AE2990 AFS CB Handheld Radio for AM, FM and SSB

Service Manual

Servicemitteilung zu AE 2990 AFS v. 21.2.2011

Service Note 2990 AFS issued 21. 2. 2011

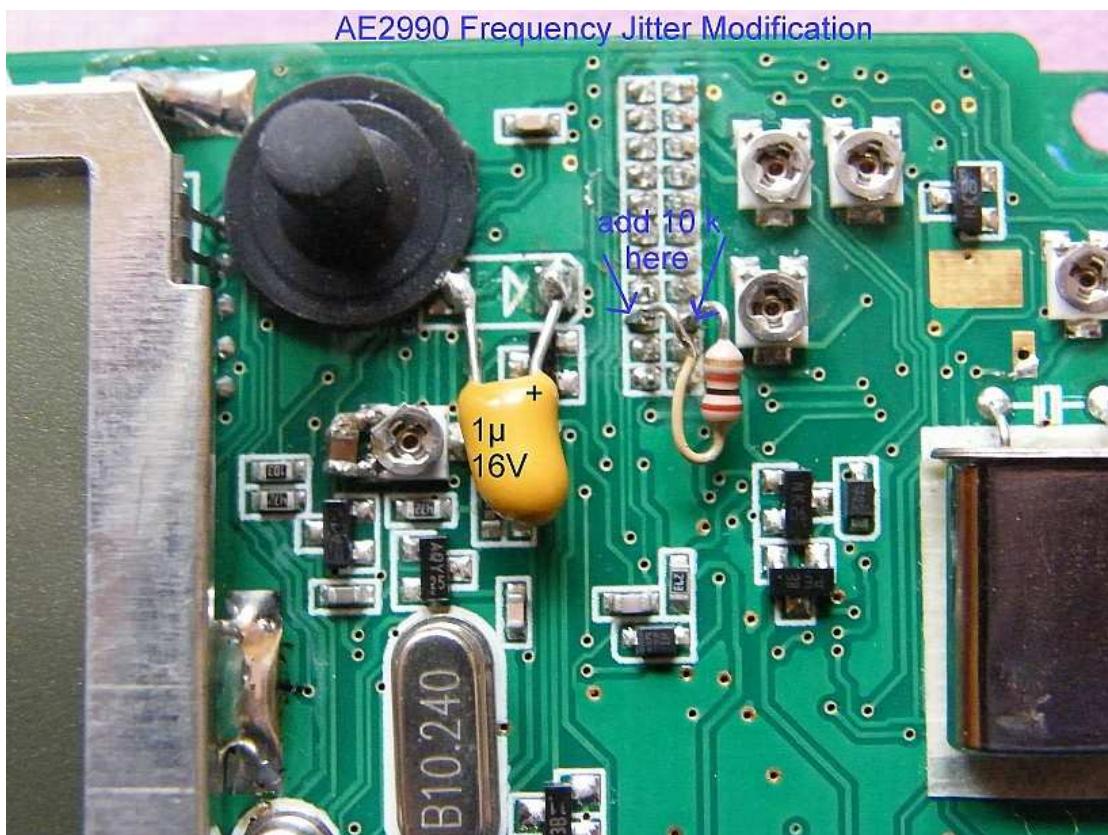
Bei einigen Geräten der ersten Produktionsserie Dezember 2011 wurde bemängelt, dass die Sendefrequenz in SSB bei starker Modulation einen kurzen Einschwingvorgang vollführt. Dieser äußert sich darin, dass z.B. beim Pfeifen in das Mikrofon der Pfeifton während der ersten 10..20 Millisekunden etwa 100..200 Hz neben der Frequenz liegt. Eine Gegenstation wird den Ton als nicht konstant bezeichnen, er ist zuerst neben der Frequenz und wird dann sauber. In Foren wird der Effekt von den Usern als „Eiern“ beschrieben, technisch trifft der Begriff Jitter den Sachverhalt besser.

Ursache: Der Lastwechsel der ansteigenden Sendeleistung bei SSB beim ersten Sprechen bewirkt eine unerwünschte HF Rückwirkung auf den VCO. Die Phasenregelschleife erkennt das als Frequenzablage und regelt nach. Das Regelverhalten reagiert dabei kurzzeitig wie ein Überschwingen.

1. Änderung eines Standard SMD Elkos von $2.2\mu\text{F}$ in einen Tantal-Elko $1\mu\text{F}$ (gelb) in der Phasenregelschleife nach obenstehendem Foto.

2. Zusätzlich kann man auch noch einen **zusätzlichen Widerstand** von ca. $10\text{ k}\Omega$ über die im Bild gezeigten Kontakte des Pfostensteckers (3. Kontaktebene von unten gerechnet, entspr. R 203) legen.

Dieser Widerstand wird aber nicht empfohlen, wenn jemand Wert auf gutes Einrasten auch im untersten und obersten der 400 Kanal-Bänder Wert legt (ggf. ausprobieren).

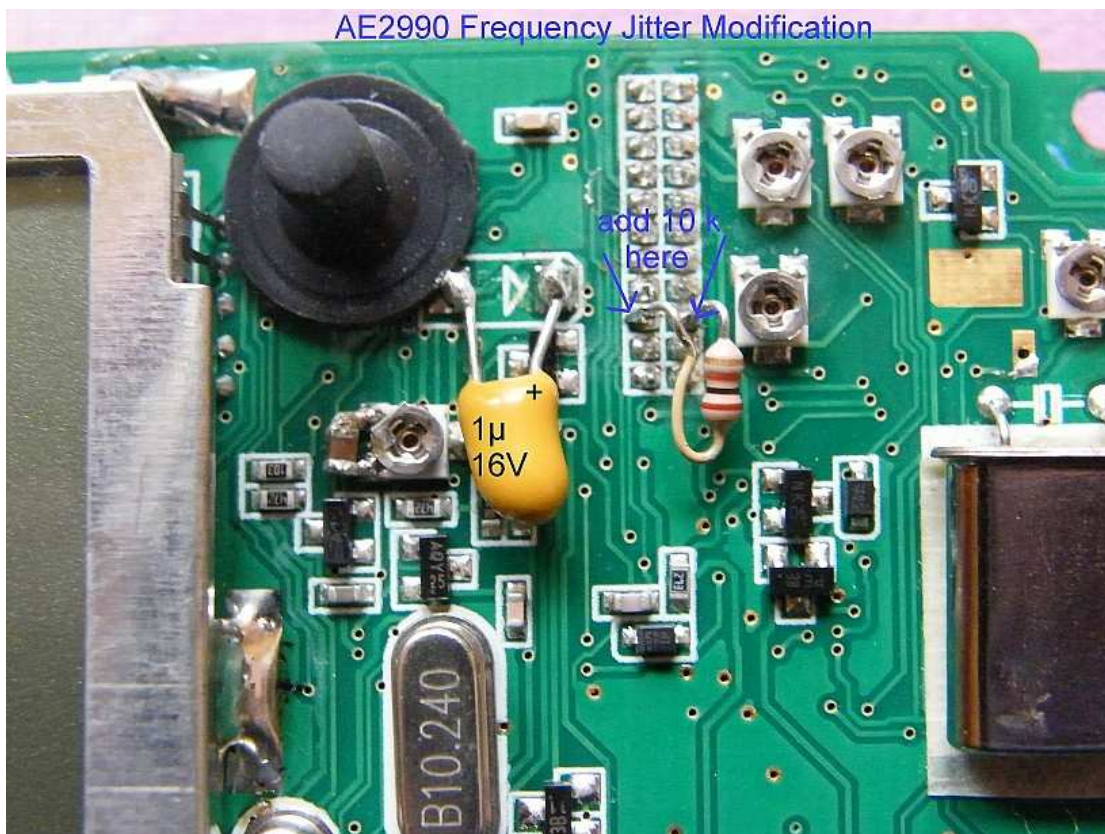
Users reported that units from first production lot show more or less a “frequency jitter” effect during strong SSB modulation. The problem occurs as frequency shift of about 100-200 Hz especially if users produce whistle tones into the microphone during the first 10..20 milliseconds of the tone duration. Distant stations report that the tone is not constant and becomes ok later.

Cause: A negative feedback from rising output power with SSB modulation can cause a short time frequency shift reaction of the VCO. The PLL and phase comparator circuits then try to compensate the VCO Varicap voltage.

1. Change the original **SMD standard capacitor 2.2 µF** into a **Tantalum capacitor of 1µF** capacity (yellow on above photo)

2. Additionally the effect can be further reduced by **adding an additional resistor 10 kOhm** parallel to the PCB plug contacts of the third row (seen from bottom). (Info: these contact points connect to R 203 on main board).

Because this additional resistor may cause longer lock-in periods on lowest and highest 400 CH band frequencies, we do not recommend this modifications to users who should use this configuration. In that case we recommend to check the lock behaviour with and without resistor.
